| Model: NAD 30S/30/40 DF (DF67)          |  | Date: 15-Oct-98   | No.: 1  |
| Subject: Original MIsfeed               |  | Prepared by: S. Hizen   |   |
| From: GTS and S Field Information Dept. |  |   |   |

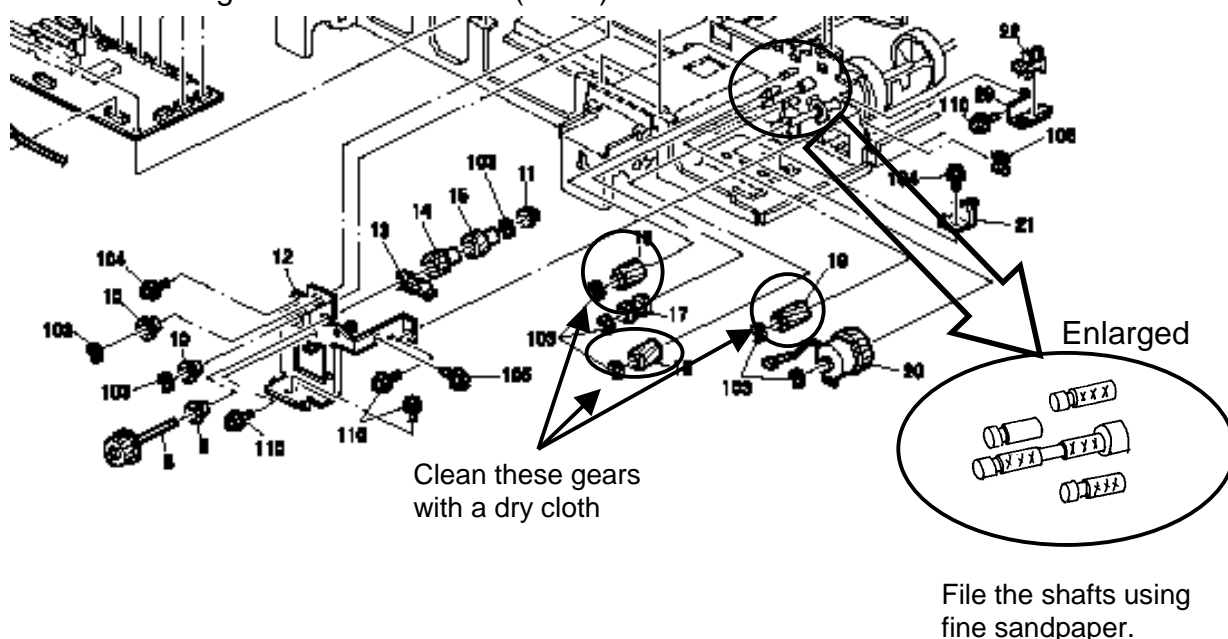
The friction between the 16Z gear and its shaft increases and exceeds the maximum torque of the feed motor. This is due to tiny burrs on the shaft.

File off the tiny burrs on the shaft and lubricate as shown in the following procedure.

1. Take off the retaining rings for the 16Z gears.
  2. File the shafts using fine sandpaper. (Do not use a metal file to file the shaft because this will increase the friction.)
  3. Clean the shafts and the inside of the gears with a dry cloth.
  4. Lubricate the shafts and the inside of the gears with plastic grease (white resin based grease for plastic parts).
  5. Reassemble the gears and the rings.
- Parts Catalog: 7. Drive Section 2 (A680) -

Increase the inside diameter of the gear. (An MB will be issued as soon as the parts are available.)
